Contract #: 04-0120F4Cty: SF/ALA Rte: 80 PM: 13.2/13.9File #: 69.25B**QUALITY ASSURANCE -- NON-CONFORMANCE REPORT****Location:** Changxing Island, Shanghai, China**Report No:** NCR-000911**Prime Contractor:** American Bridge/Fluor Enterprises, a JV**Date:** 24-Nov-2010**Submitting Contractor:** Zhenhua Port Machinery Company, Ltd (ZPMC), Changxing Island**NCR #:** ZPMC-0873**Type of problem:****Welding****Concrete****Other****Welding****Curing****Procedural****Bridge No:** 34-0006**Joint fit-up****Coating****Other****Component:** Lift 14W, FB3343-001-340**Procedural****Procedural****Description:****Reference Description:** New Welding Procedure Not Followed**Description of Non-Conformance:**

<b>To:</b>	AMERICAN BRIDGE/FLUOR, A JV 375 BURMA ROAD OAKLAND CA 95607	<b>Date:</b>	25-Nov-2010
<b>Dear:</b>	Mr. Charles Kanapicki	<b>Contract No:</b>	04-0120F4 04-SF-80-13.2 / 13.9
<b>Attention:</b>	Mr. Thomas Nilsson Project/Fabrication Manager	<b>Job Name:</b>	SAS Superstructure
<b>Subject:</b>	NCR No. ZPMC-0873	<b>Document No:</b>	05.03.06-000868
<b>Reference Description:</b>	New Welding Procedure Not Followed

**Subject:** NCR No. ZPMC-0873

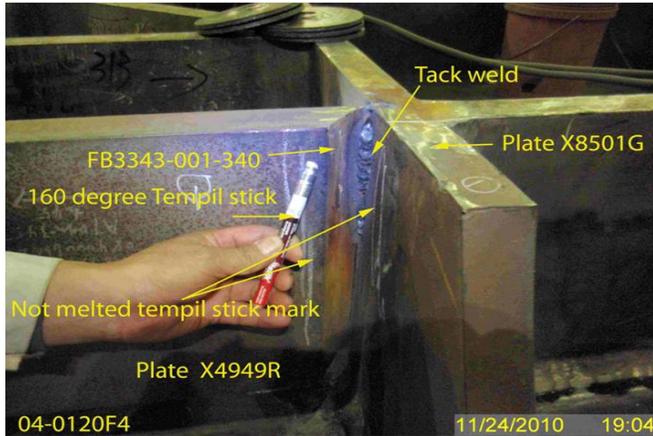
During Caltrans QA in process observations of the fabrication of FB3343-001-340, this QA discovered the following issue(s): ZPMC welding personnel did not appear to be following the NEW WELD PROCEDURE (Rager / McQuaid)

2. Assembly (2E, 2F)

The weld is identified as FB3343-001-340

The welding process used was FCAW

The area was being preheated using Torch

The weld is a CJP joining X4949R to X8501G

See attached photograph for additional detail.

CT acknowledges contractor's response. However, successful NDT will close this NCR.

This proposed resolution is acceptable. The documentation received is sufficient and the Department concurs that Non-Conformance ZPMC-0873 is closed.

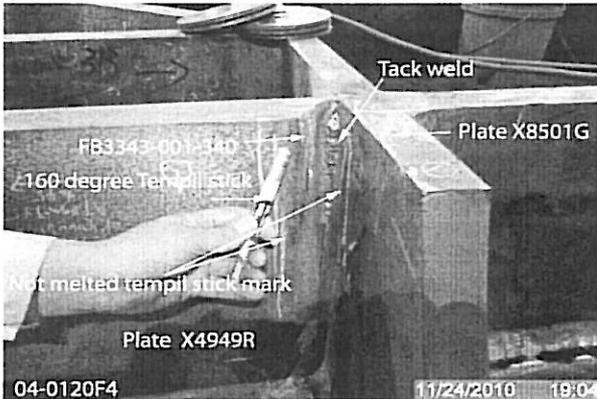
During Caltrans QA in process observations of the fabrication of FB3343-001-340, this QA discovered the following issue(s): ZPMC welding personnel did not appear to be following the NEW WELD PROCEDURE (Rager / McQuaid)

2. Assembly (2E, 2F)

The weld is identified as FB3343-001-340

The area was being preheated using Torch

The weld is a CJP joining X4949R to X8501G

See attached photograph for additional detail.

Contractor will provide the NDT report to prove the weld is acceptable.

NDT report was provided by the Contractor showing the weld is acceptable.
